ADDENDUM NO. 1 TO CITY OF AUBURN, MAINE 2018 RECLAMATION PROJECT March 28, 2018

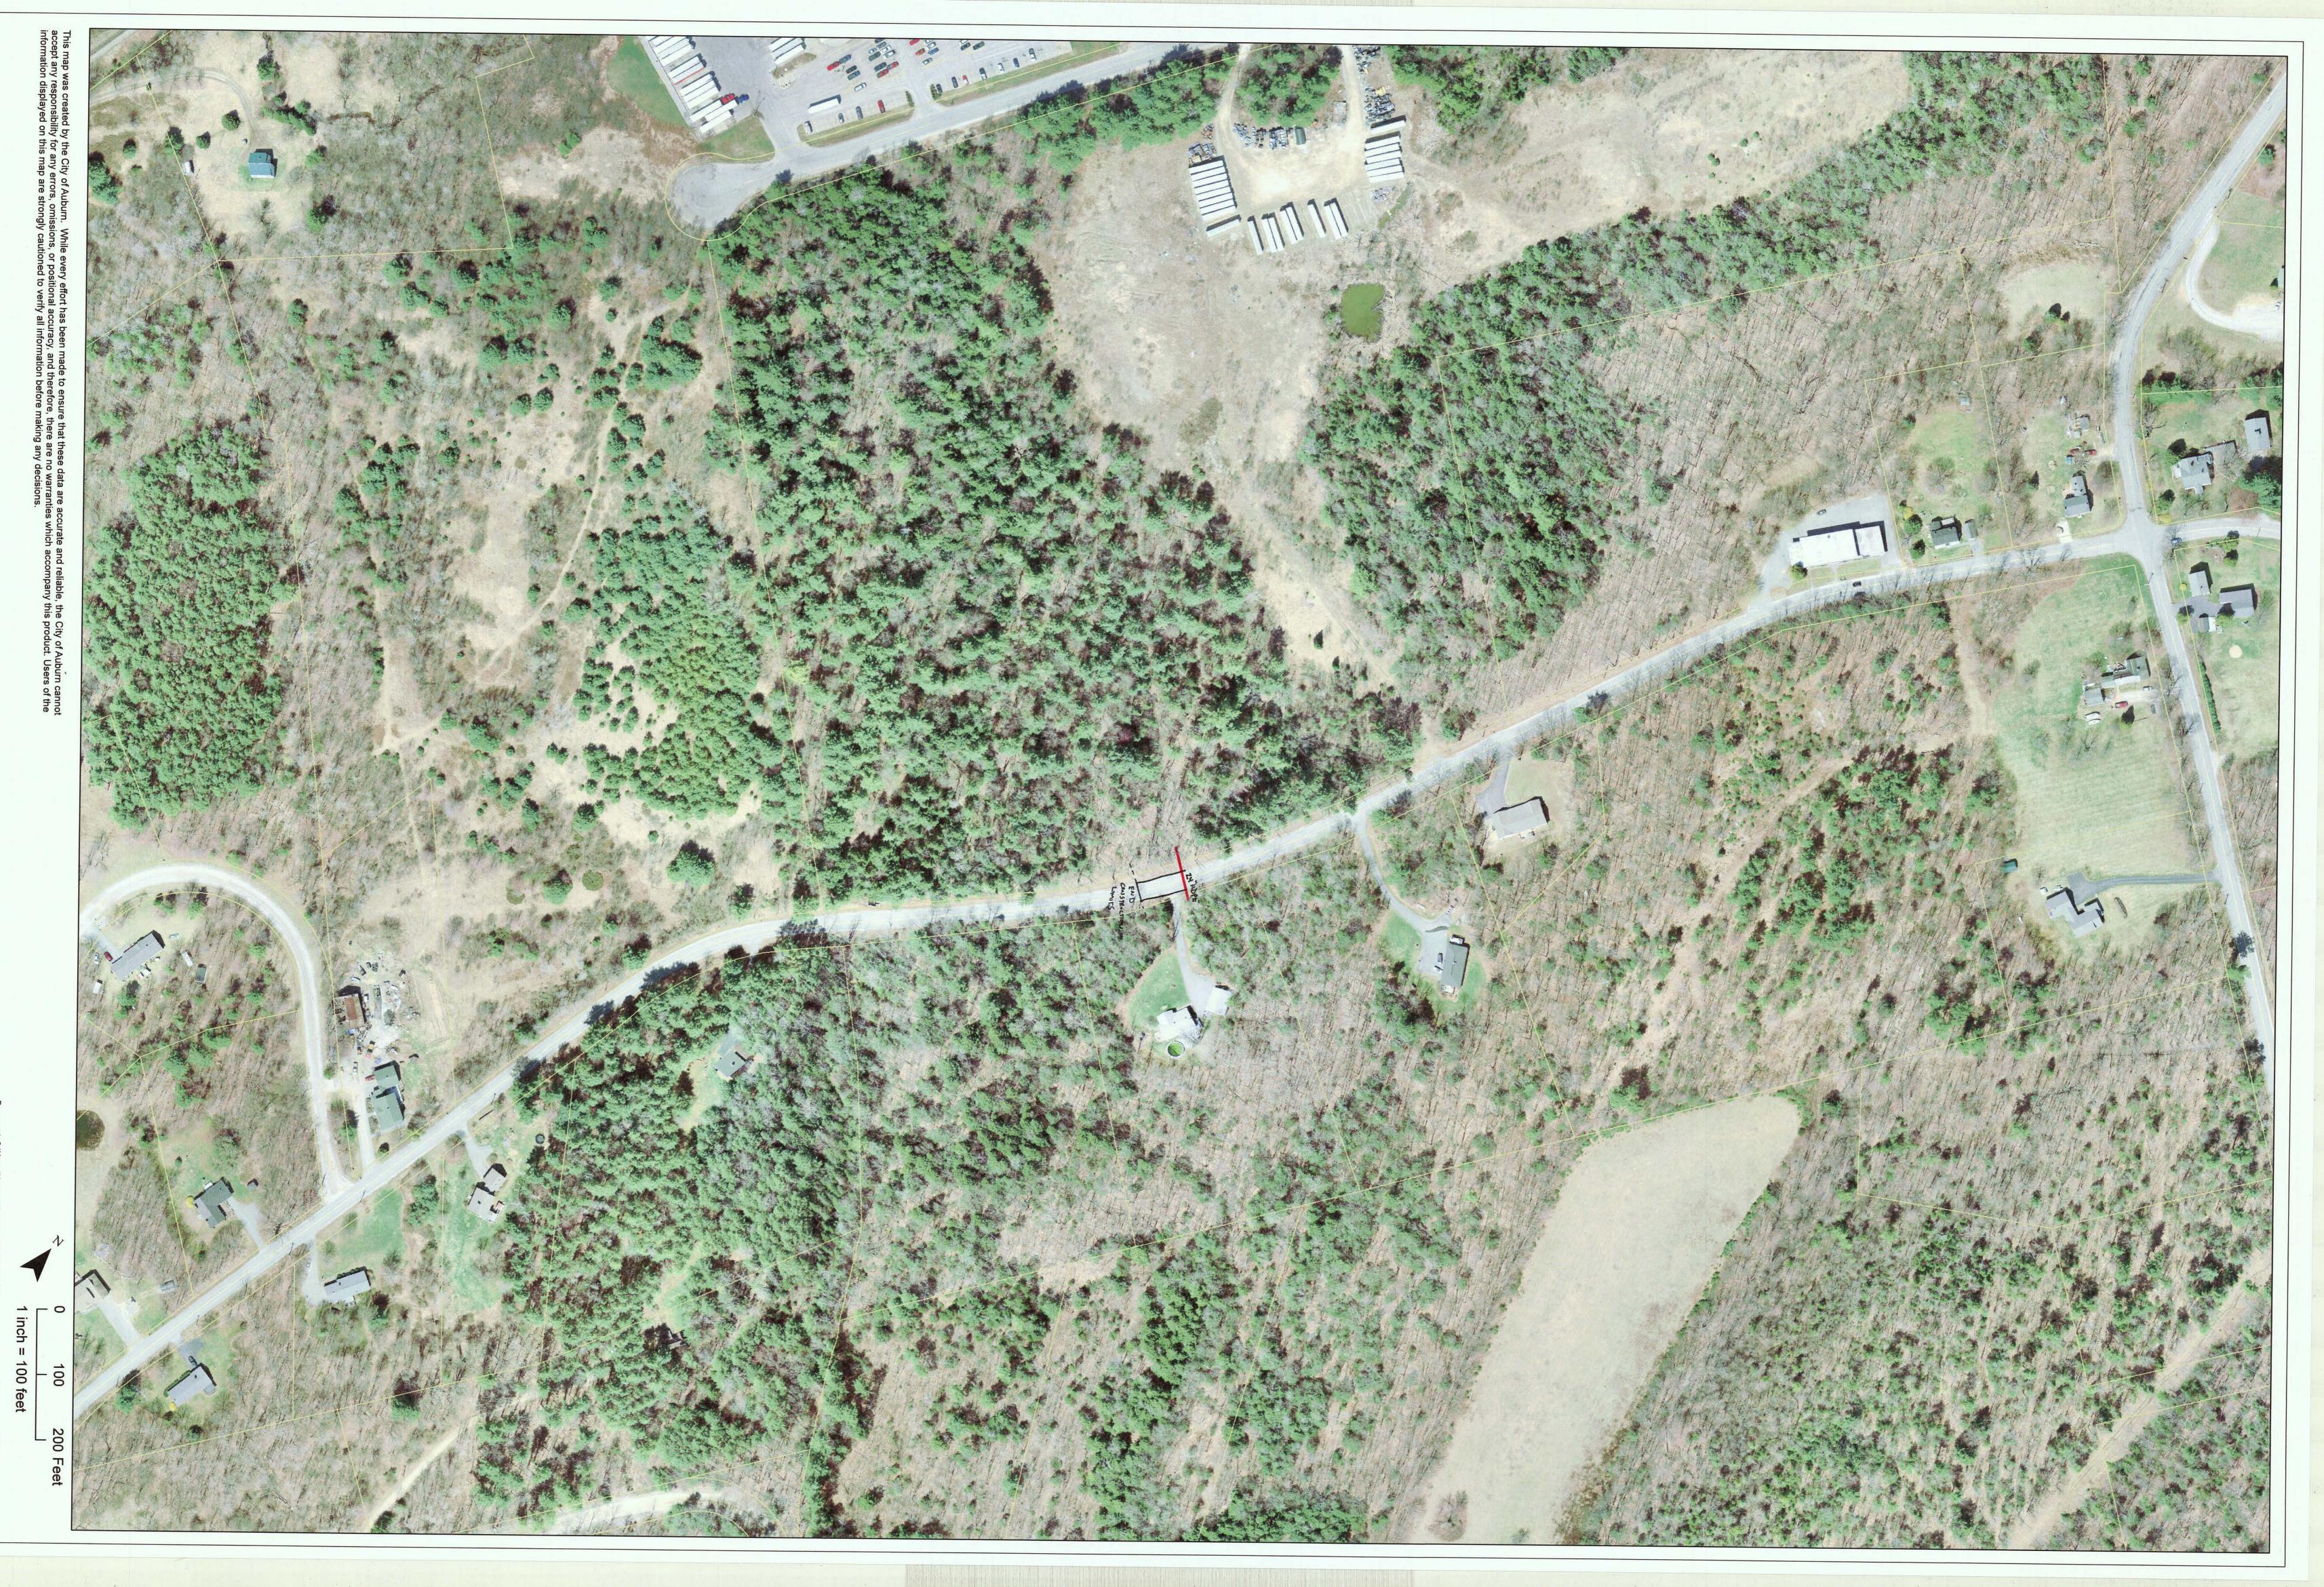
Attached mark up of construction limits.
